**JULY 15, 2014 ZONING HEARING
“OTHER BUSINESS”
COMMISSION DISTRICT 4**

ITEM OB-43

To consider amending and clarifying zoning stipulations for Can Nguyen regarding rezoning application Z-14 of 2014, for property located on the north side of South Gordon Road, east of Starling Drive; in Land Lots 386 and 412 of the 18th District.

540 SOUTH GORDON ROAD
MARIETTA GA 30126
MEDITATION CENTER

SITE PLAN

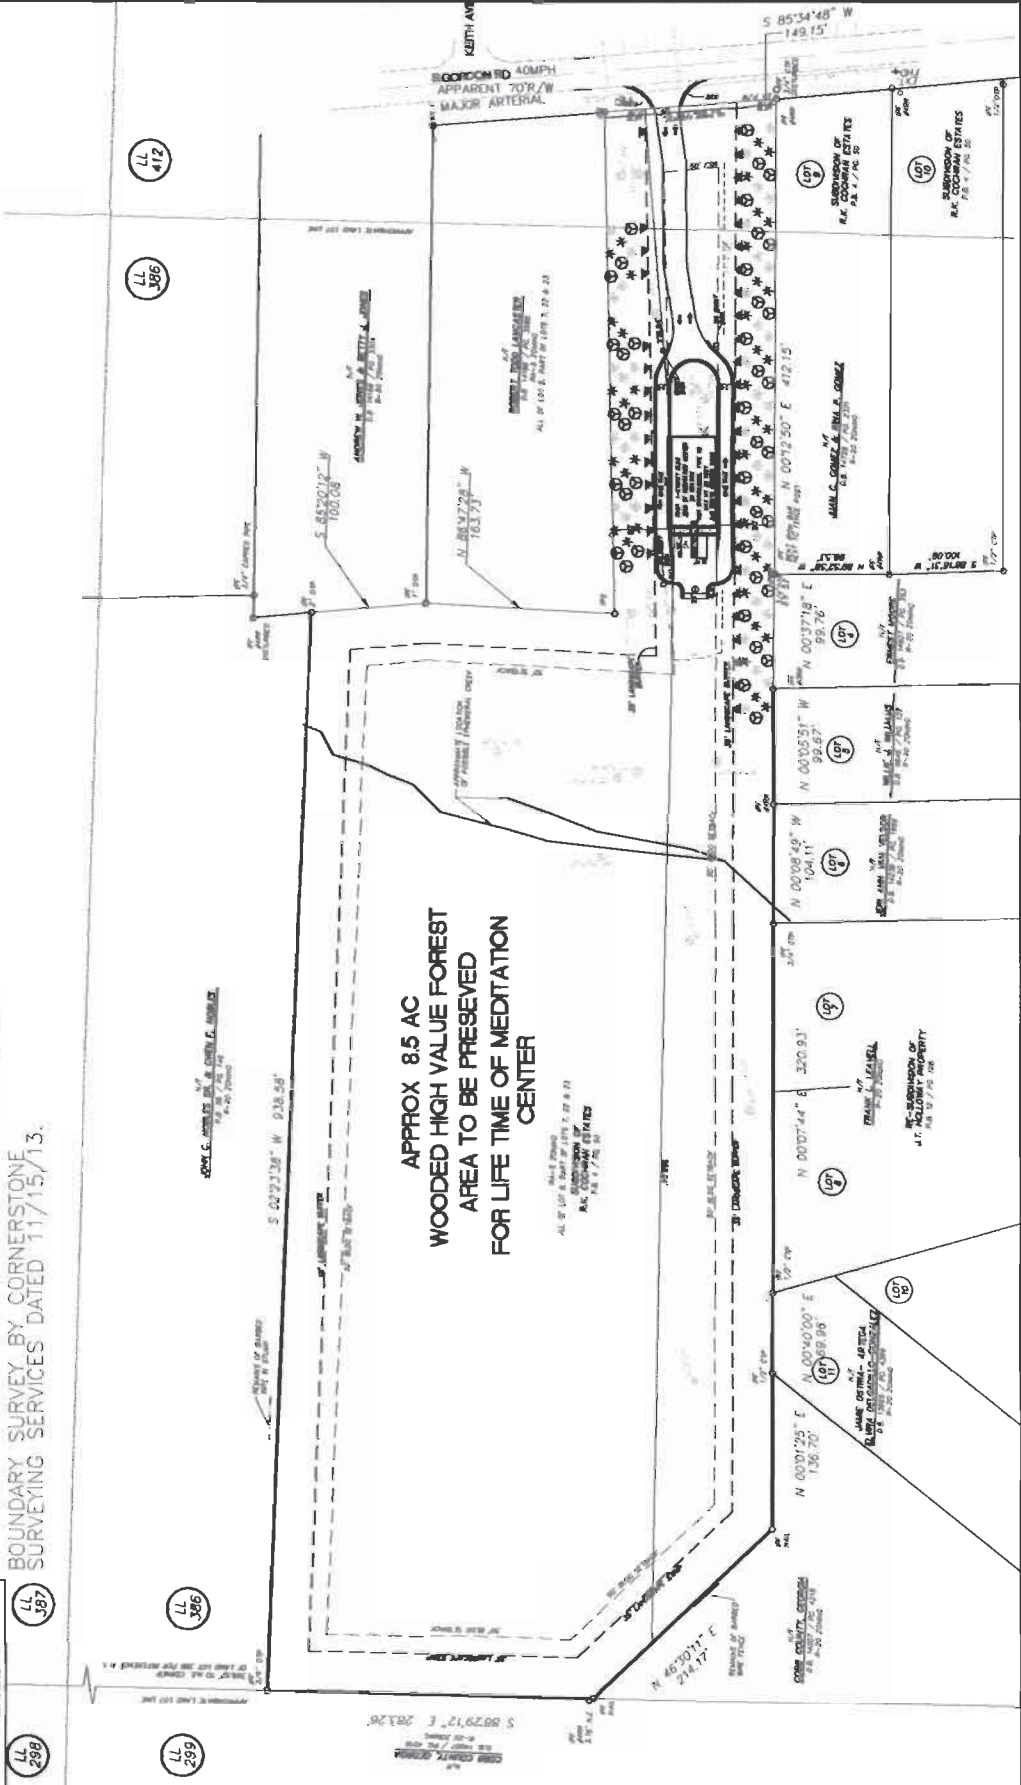
The required parking for the proposed use is one space per four seats. The site plan indicates the required five parking spaces for 20 seats.

ACCESS: Fire apparatus access roads shall extend to within 150 feet of all portions of the facility or any portion of the exterior wall of the first floor (State Modifications IFC 503.1 2006 Edition).

All access roads shall meet the American Association of State and Highway Transportation Officials (AASHTO) design manual live load standard HS20 (75,000 lbs.) with an unobstructed width of not less than 20 feet, 25 foot inside radius, 50 foot outside turning radius and unobstructed vertical clearance of not less than 13 feet 6 inches.

Dead-end access roads in excess of 150 feet shall be provided with a turn-around (IFC 503.2.5 2006 Edition). Cul-de-sac with or without an island: minimum 60-foot radius to outside curb, measured to inside of curb and a minimum lane width = 24 feet (Cobb County Development Standard 401.09). Single-Family cul-de-sac without island: 38-foot outside radius with island reverts to commercial dimensions. Hammerhead turn-around: total of 110 feet needed (45 feet + 20 feet wide roadway + 45 feet).

HYDRANT: Show fire hydrants arranged to have a hydrant available for the distribution of hose to any portion of any building on premises at distances not exceeding 500 feet (driving distance). Hydrants shall be at least 40 feet from the building (steamer connection facing street) (NFPA 24-7.2.3). Fire hydrants shall be spaced not more than 500 feet apart. Hydrants shall not be connected to water lines on the positive side (discharge side) of a fire pump. Minimum 8” supply lines to all hydrants.

- Provide comprehensive hydrology/stormwater controls to include development of out parcels.
- Submit all proposed site improvements to Plan Review.
- Any **spring activity** uncovered must be addressed by a qualified geotechnical engineer (PE).
- Structural fill _____ must be placed under the direction of a qualified registered Georgia geotechnical engineer (PE).
- Existing facility.
- Project must comply with the Water Quality requirements of the CWA-NPDES-NPS Permit and County Water Quality Ordinance.
- Water Quality/Quantity contributions of the existing lake/pond on site must be continued as baseline conditions into proposed project.
- Calculate and provide % impervious of project site.
- Revisit design; reduce pavement area to reduce runoff and pollution.

- No Stormwater controls shown _____
- Copy of survey is not current – Additional comments may be forthcoming when current site conditions are exposed.
- No site improvements showing on exhibit.

South Gordon Road is classified as a major collector and according to the available information the existing right-of-way does not meet the minimum requirements for this classification.

The subject property was rezoned for a meditation center May 20, 2014 subject to numerous stipulations. One of the stipulations adopted called for the building to be setback at least 490 feet from South Gordon Road. This Other Business item is to consider amending the zoning stipulation, so the setback is more in keeping with the site plan shown in the zoning analysis.

- All buildings and parking to be located in the interior portion of the property setback at least 490 feet from South Gordon Road
- Landscape or naturally maintained buffer of 35 feet on all property lines with the exception of South Gordon Road and the first 50 feet from South Gordon Road; landscape buffer with the purpose of providing visual and sound screening to be provided along the property lines adjacent to the driveway and parking lot areas; landscaping to be provided in the first 50 feet from South Gordon Road with landscape beds to include a variety of plants and shrubs; all buffers to be maintained and dead plants to be replaced within 60 days

ZONING DRAWING FOR ZONING CASE NUMBER Z-163
PRESSLEY-ALLEN PROPERTIES, LLC
LOCATED ON LAND LISTED AS OF THE 1992 RECORD

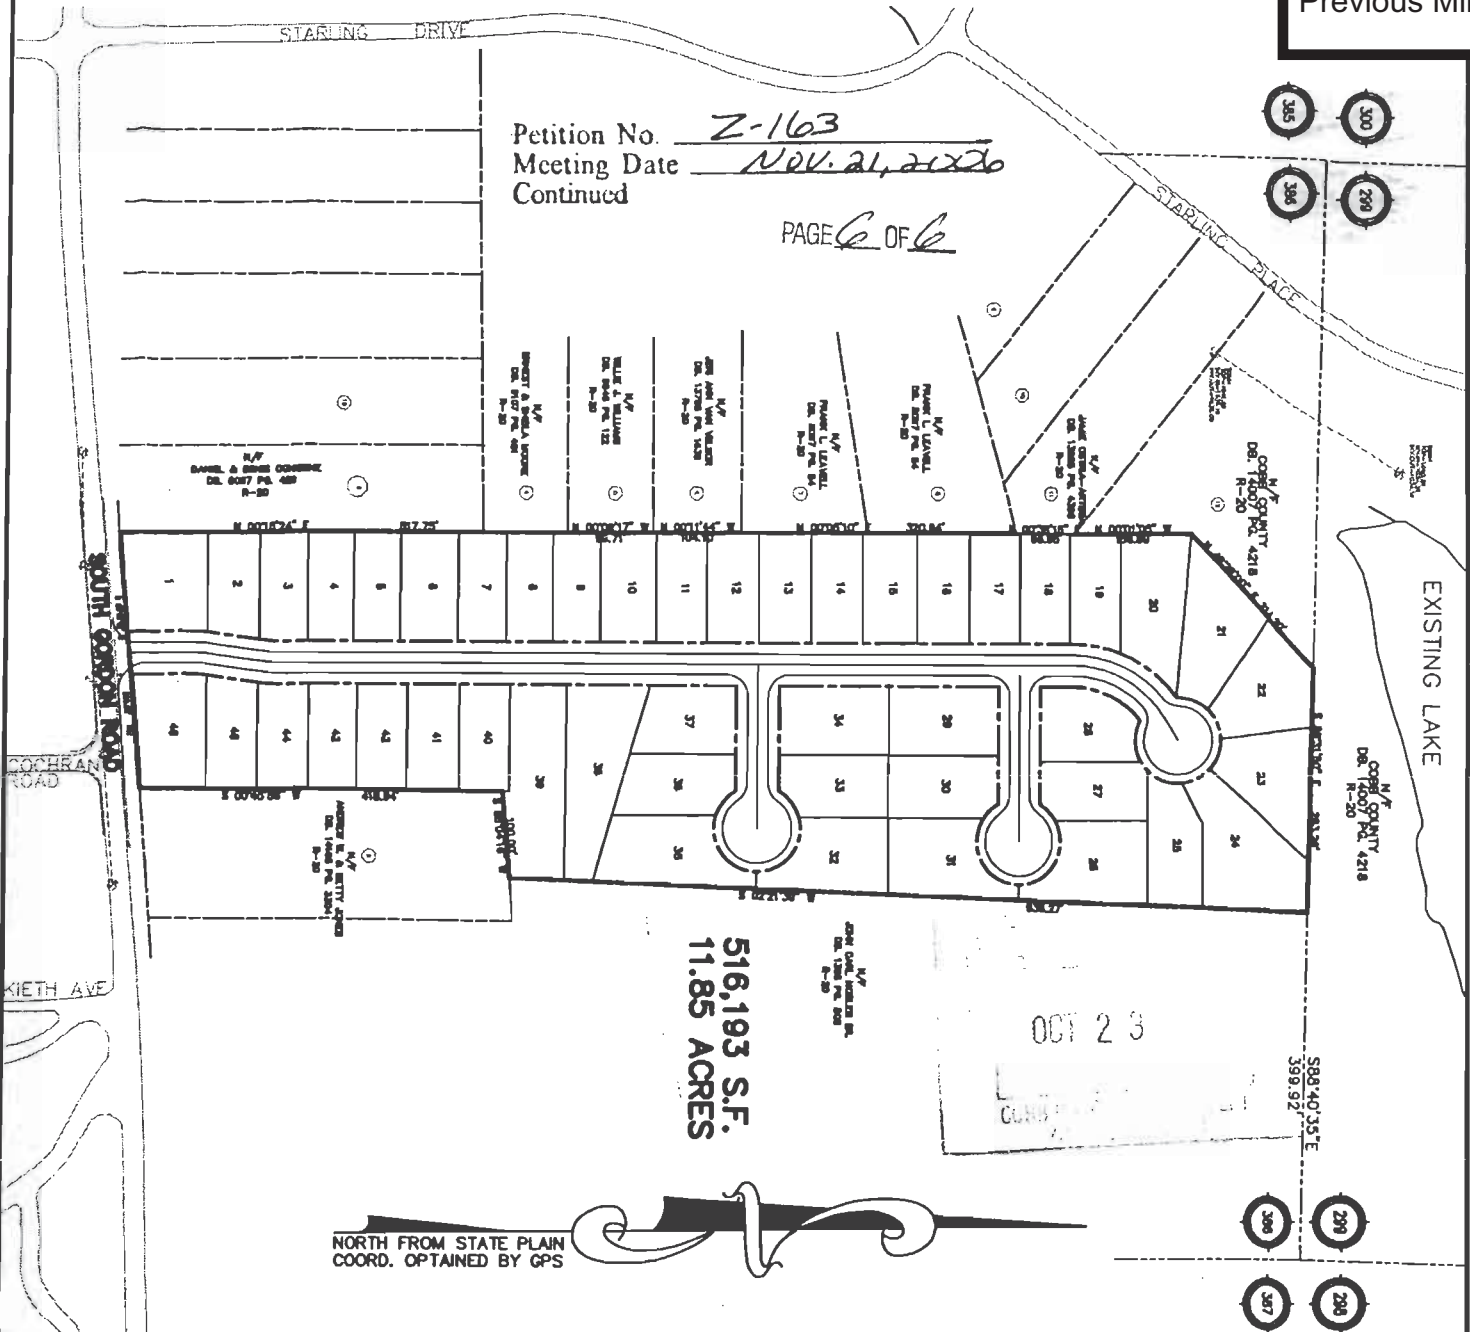
- No Stormwater controls shown for southern portion of site - **must be addressed at Plan Review.**
- Copy of survey is not current - Additional comments may be forthcoming when current site conditions are exposed.

1. This site drains generally to the northwest via two fairly well-defined channels through existing residential parcels for the southern half of the site and via overland flow into an existing lake owned by Cobb County for the northern half of the site.

2. A single stormwater management facility is proposed at the northwestern corner of the site. The pond lot provided does not appear large enough to provide adequate detention for the entire site. It may be possible to utilize the existing downstream Cobb County lake for detention if a suitable agreement can be reached with the County. However, if an agreement cannot be negotiated additional area for detention will likely be required. Also, unless a significant portion of the southern half of the site and upstream offsite drainage area can be intercepted and conveyed directly to the proposed detention facility additional ponds may be required at Lots 2 and 11 to meet downstream discharge limitations.

3. The extensive existing tree stand and undergrowth provide significant air/water quality, soil stabilization and storm flow mitigation benefits for this watershed. Construction of this project will eliminate the vast majority of this vegetation and increase pavement, storm runoff and non-point source pollution. To compensate, the First Flush Water Quality Best Management Practice Requirements must be elevated to the 1.5-inch rainfall event and each larger storm discharge controlled not to exceed the allowable discharge of the next lower, more frequent storm event (ie. 5-year storm event released at 2-year rate; 10-year event at 5-year rate; etc. to 100-year event at 50-year rate).

As necessitated by this development for egress from South Gordon Road, a deceleration lane and a left turn lane will be required.

Recommend applicant consider entering into a development agreement pursuant of O.C.G.A. 36-71-13 for dedication of the following system improvements to mitigate traffic concerns: a) donation of right-of-way on the north side of South Gordon Road, a minimum of 40' from the roadway centerline.

Recommend installing sidewalk, curb and gutter along the frontage.

Recommend a deceleration lane and a left turn lane.
